**ANN ARBOR HISTORIC DISTRICT COMMISSION****Staff Report****ADDRESS:** 1327 Jones Drive, Application Number HDC11-074**DISTRICT:** Northern Brewery Historic District**REPORT DATE:** June 3 for the June 9, 2011 HDC Meeting**REPORT PREPARED BY:** Jill Thacher, Historic Preservation Coordinator**REVIEW COMMITTEE DATE:** Monday, June 6, 2011**OWNER**

**APPLICATION:** The applicant seeks HDC approval to add an egress door and two windows, all in new openings, and an associated egress well, on the west basement elevation; and to add a below-grade 'grade beam' that will prevent further bowing of the west wall, and structural straps with earthquake washers at the floor level of the first floor.

**THE NORTHERN BREWERY  
 BASEMENT  
 NEW MEZZANINE**

**WALL SECTION @ NEW WINDOW**  
 SCALE 1/2" = 1'-0"

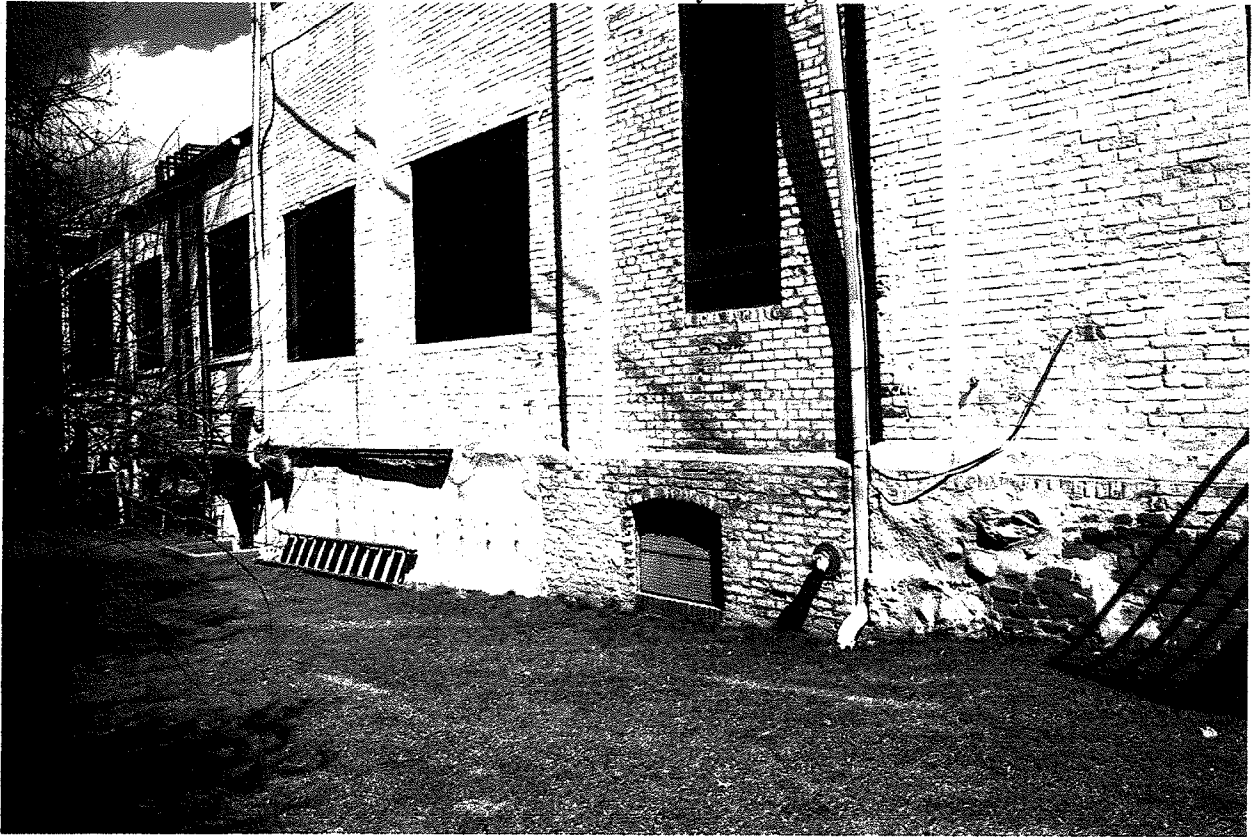
4. The below-grade concrete beam would extend 4'6" from the existing basement wall and extend down 7'. The beam would prevent the existing field stone wall from moving any farther outward for a length of about 35'. Ten wall ties would be installed through the brick

and into the floor joists for additional structural support. Round plates approximately 6" in diameter would secure the ties on the exterior of the building just above the proposed windows. (This reinforcement is similar to the historic metal stars often seen on the exterior of nineteenth century brick buildings.)

5. The proposed work would correct existing structural difficulties and deficiencies while allowing previously vacant space to be utilized. The two proposed windows are different in proportion from the existing basement window nearby, though they are stylistically quite similar. Staff suggests that new brick, rather than reclaimed, be utilized in the new opening to assure that it reads as an alteration rather than an original feature. The portion of the building where the work is proposed is generally not character-defining.
6. The proposed work is generally compatible in exterior design, arrangement, texture, material and relationship to the rest of the building and the surrounding area and meets *The Secretary of the Interior's Standards for Rehabilitation*, in particular standards 2, 5, and 9, and the guidelines for health and safety and windows.

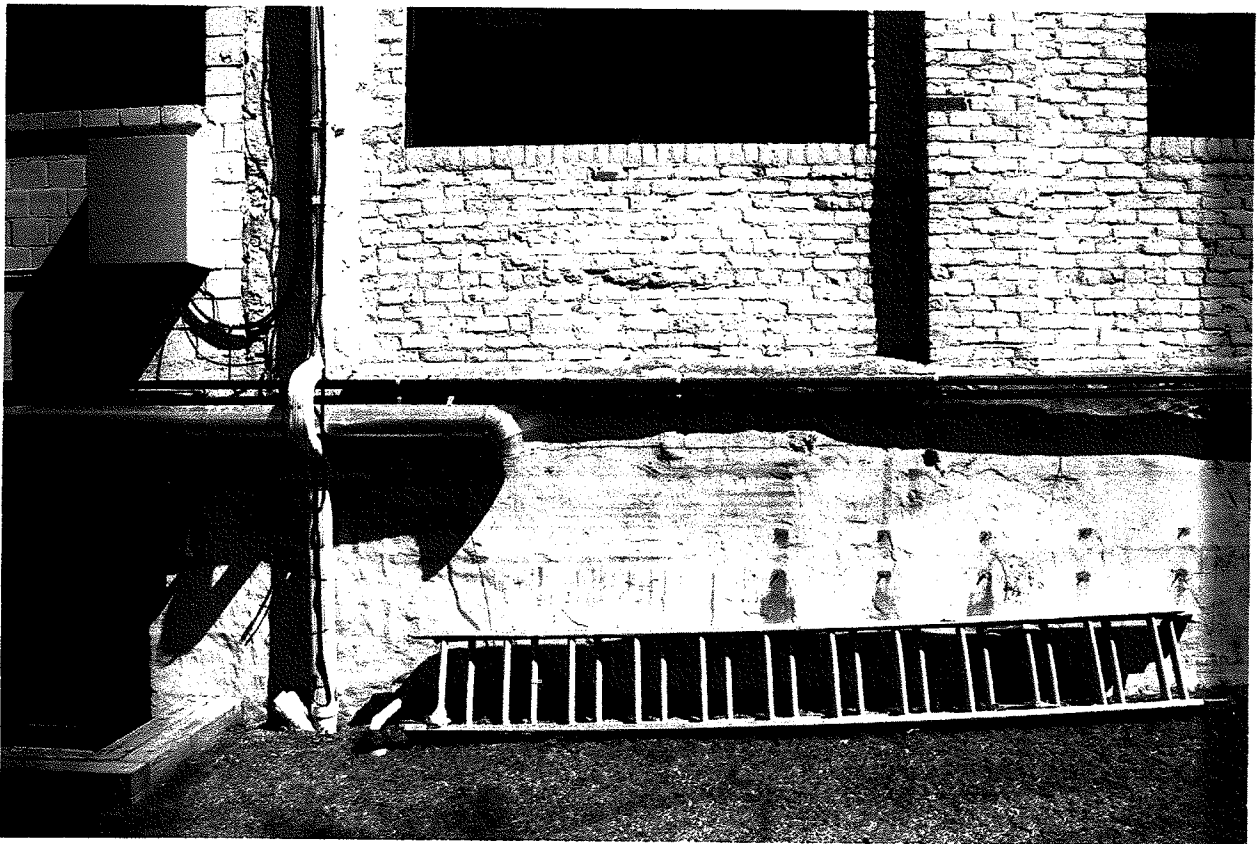
1. The proposed new door and windows on the west elevation would be dark-bronze colored aluminum to match the building's existing windows and doors. In addition, a matching window would be installed in the existing basement window opening on the west elevation, which currently has a fitted metal panel instead of glazing (see page one of the exterior photos).
